Re: Labor Building - Window Replacement
SCO # 22-25223-01A Code: 42101 Item: 4218

Addendum No. 2

P20 TYPICAL EXISTING 45 MINUTE FIRE RATED STEEL WINDOW CHECK RAIL - WINDOW TYPES C & CL SCALE : 3" = 1'-0"

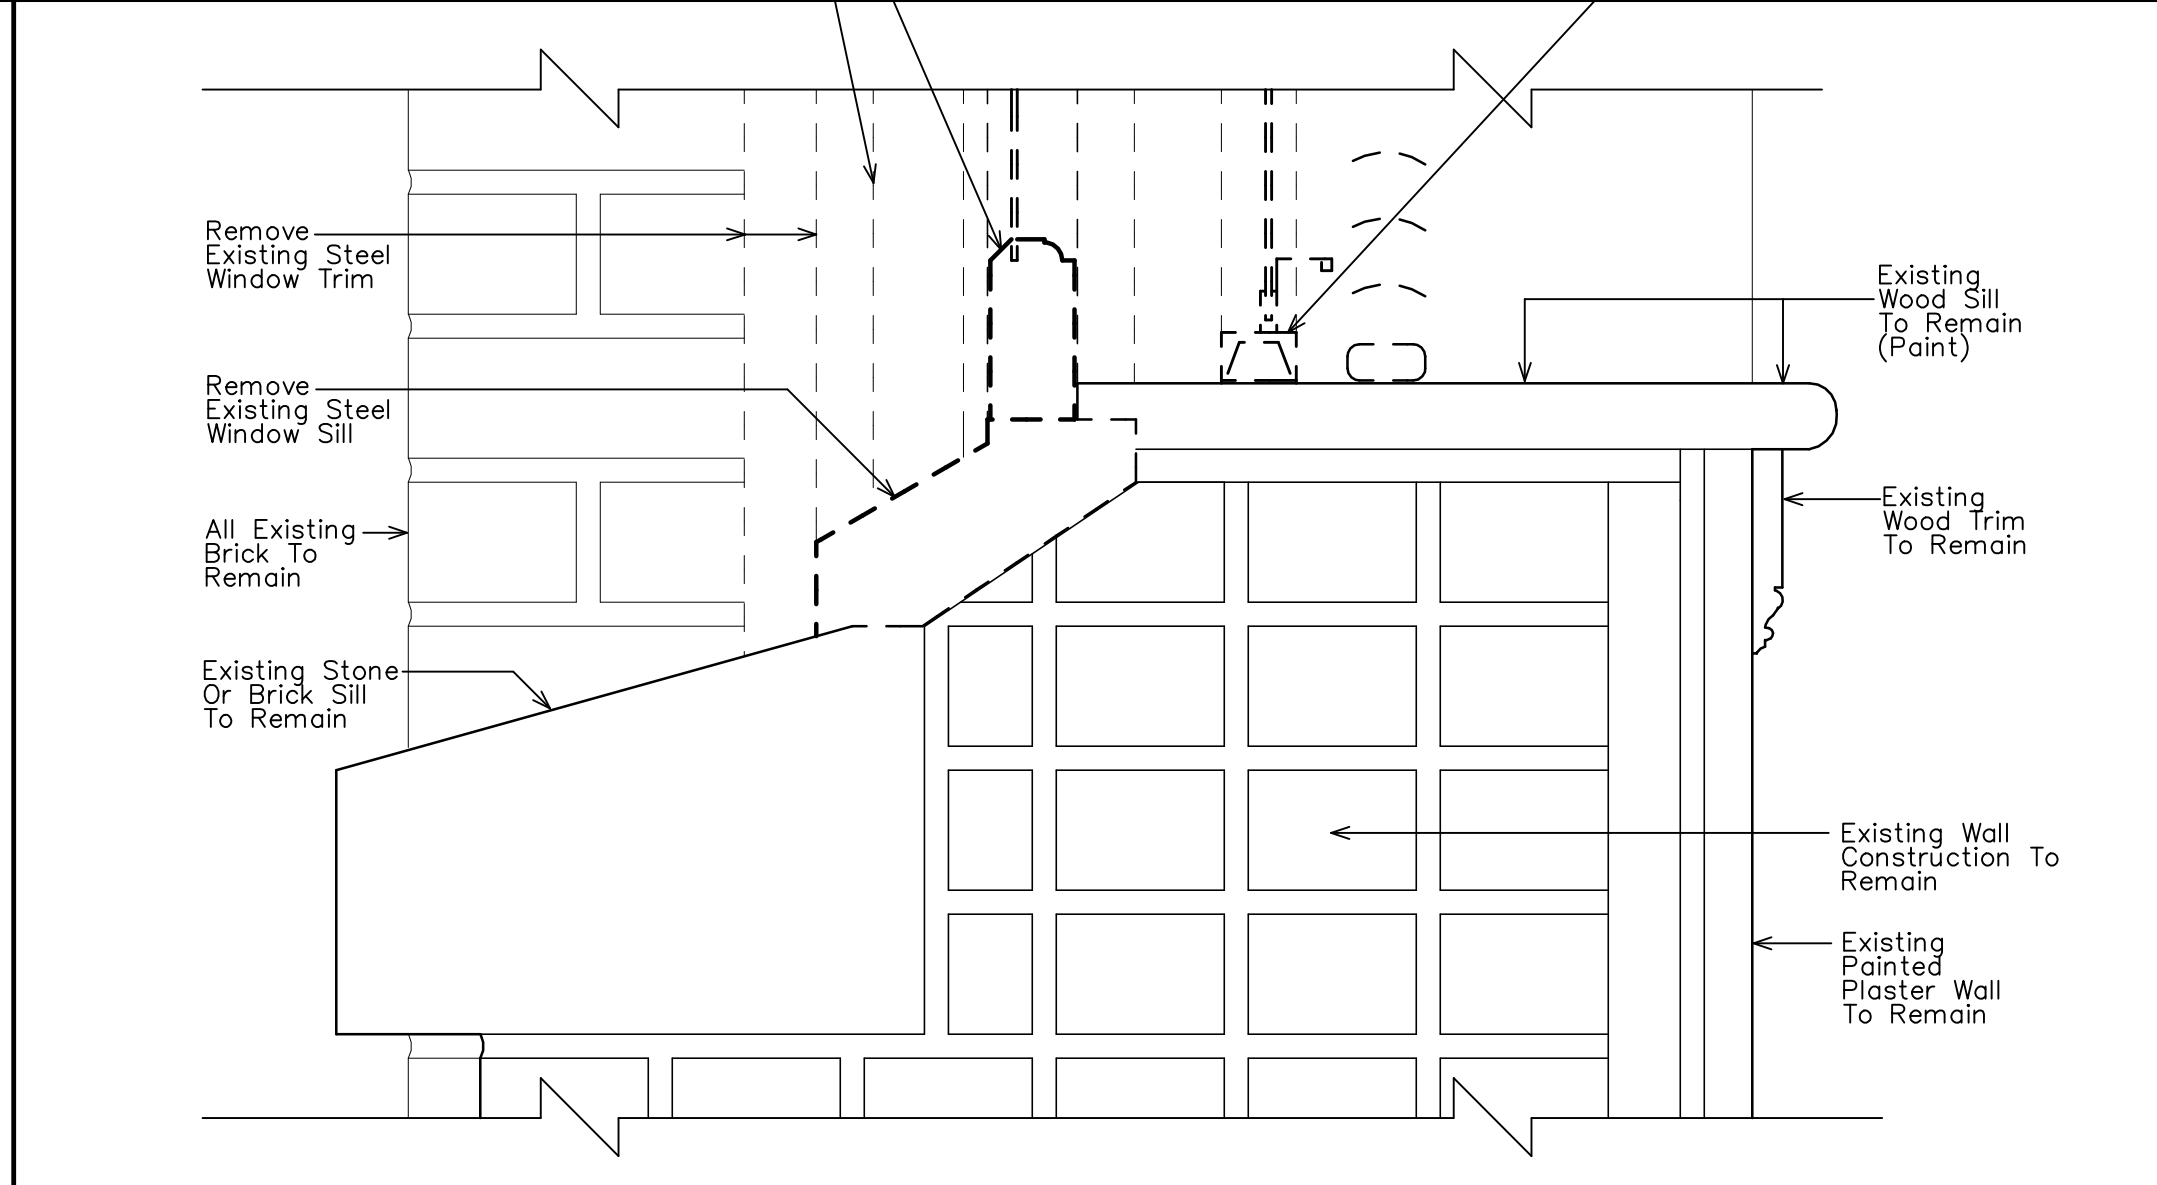
Revise Note Text at Details H09, M09, and V09 / Sheet A-6 From "TYPE A / AL" to "TYPE C".
Reissued Revised Drawing A-6 is included.

ADDENDUM No. 2:
18 OCT 2023
Revised Note Text At Details H09, M09, And V09 From TYPE A / AL To TYPE C.
